COUNTY OF LOUDOUN
DEPARTMENT OF PLANNING
MEMORANDUM

SUBJECT: September 23, 2008 Planning Commission Committee of the Whole
Loudoun County Public Schools – Lenah Property
SPEX 2008-0017, CMPT 2008-0007

SPEX 2008-0017, CMPT 2008-0007
LOUDOUN COUNTY PUBLIC SCHOOLS – LENAHA PROPERTY
PLANNING COMMISSION BRIEFING QUESTIONS
September 23, 2008 Planning Commission Worksession

**PLANNING COMMISSION BRIEFING QUESTIONS
September 23, 2008 Planning Commission Work Session
(Responses Prepared by Loudoun County Public Schools)**

ATTACHMENT 4

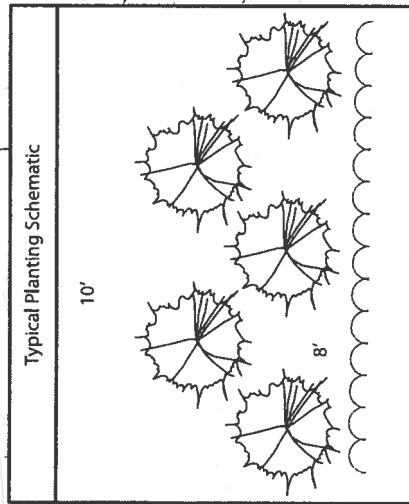
41. West boundary buffer – delineate the property line relative to the buffer. Is any of the illustrated buffer (on the plat) on the adjoining property? Will the buffer on the property meet standards?
42. Provide an illustrative explaining the different types of buffers and when they are required.
43. Is there an alternative to a long, straight berm along northern property line?

Response: A Type II Side Buffer is required along the western property boundary. The Type II Side Buffer standard provides for a width of 20 foot minimum and 30 foot maximum with two canopy trees, 4 understory trees, 10 shrubs, and 2 evergreen trees per 100 linear feet. An enhanced Type II Side Buffer is proposed along the majority of the western boundary. The enhanced planting provides for 7 additional evergreen trees and 2 additional canopy trees per 100 linear feet. LCPS has met with the owners of MCPI 287-46-9040 to discuss their concerns for the proposed application and to provide additional landscaping between the school and the single family home use. The owners expressed a desire to keep the existing vegetation in order to retain mature landscaping (instead of having the enhanced Type II buffer) and expressed a desire to have a greater buffer width. Given the layout of the proposed fields, LCPS offered to provide additional landscaping on the owner's property. There will be a 25 foot in width Type II buffer on the school property which will meet the required buffering standards. In addition, LCPS has agreed to plant a double row of Leyland Cypress on the west side of the common boundary (on MCPI 287-46-9040), providing a substantial buffer and exceeding the buffering requirements. Please reference **Exhibit 4**.

FRONT YARD BUFFER COMPARISON

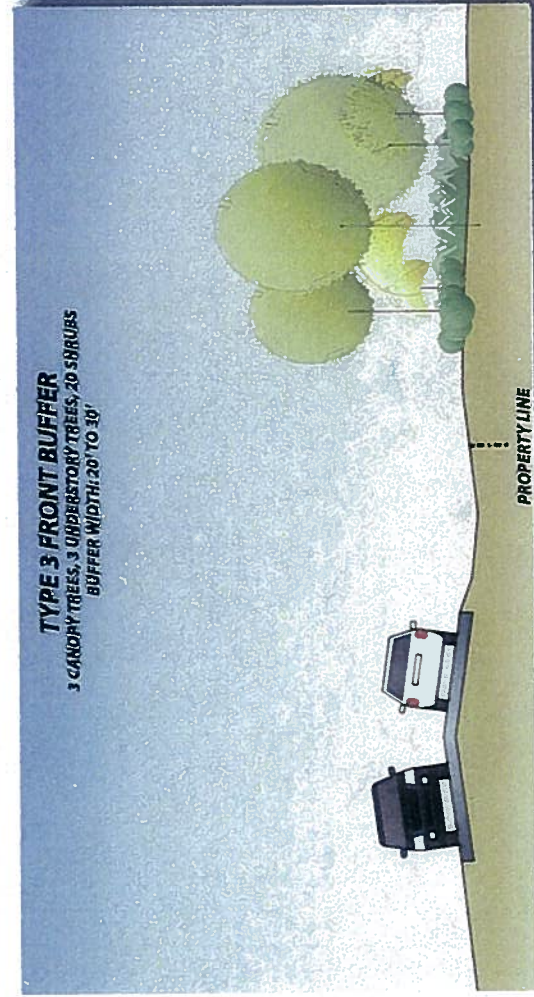
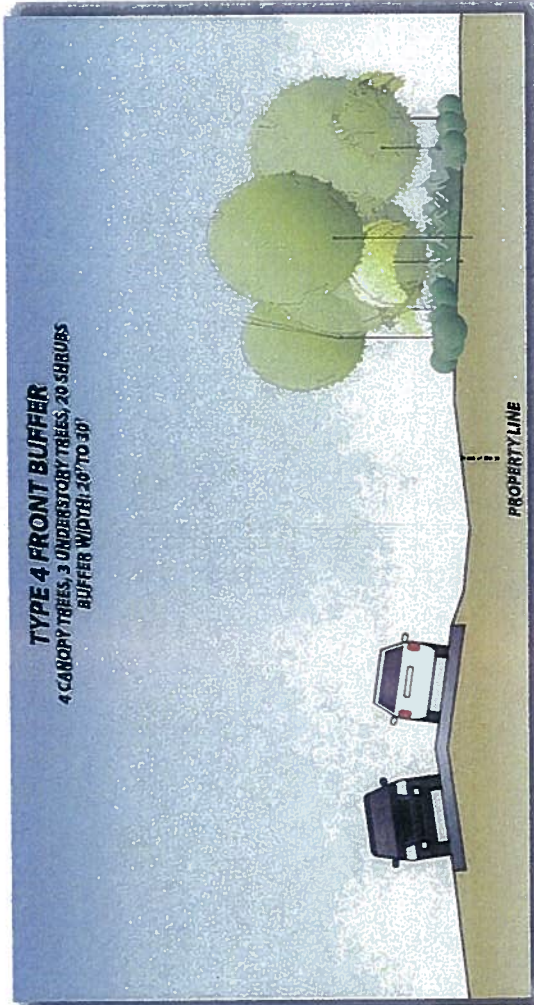
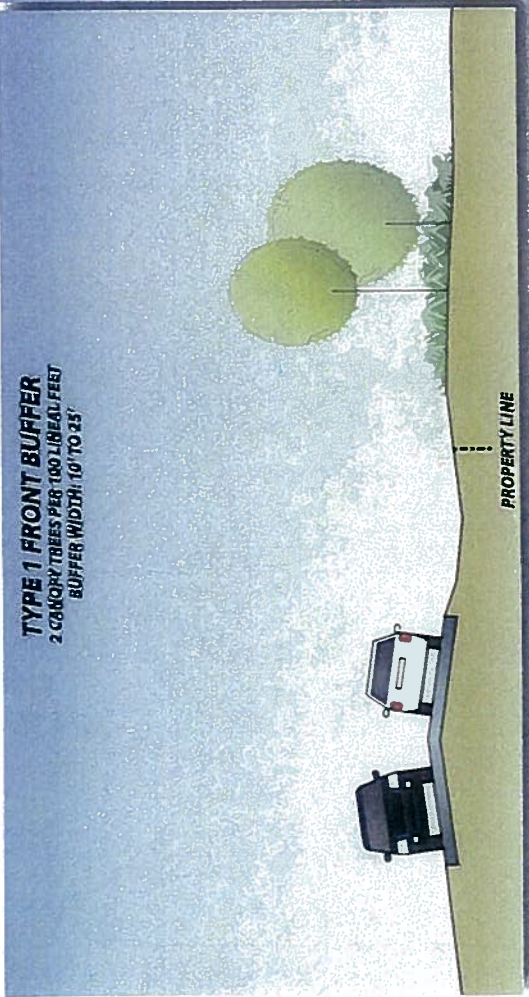
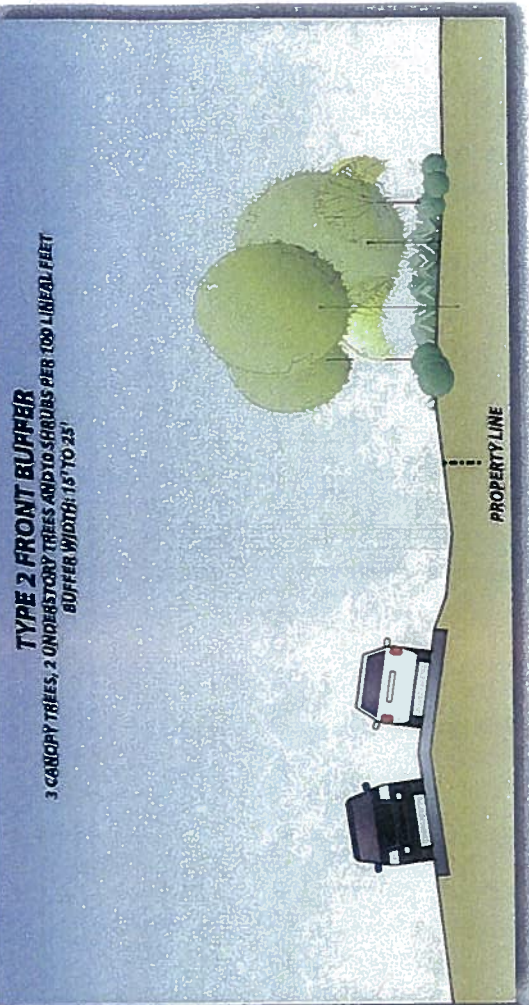
42. Provide an illustrative explaining the different types of buffers and when they are required.

Response: Table 5-1414(A) of the Zoning Ordinance regulates the type of buffer required between land uses. Table 5-1414(B) describes the required plantings for each buffer type. These two tables along with an illustrative depicting the differences between these buffer types is included at **Exhibit 5**.
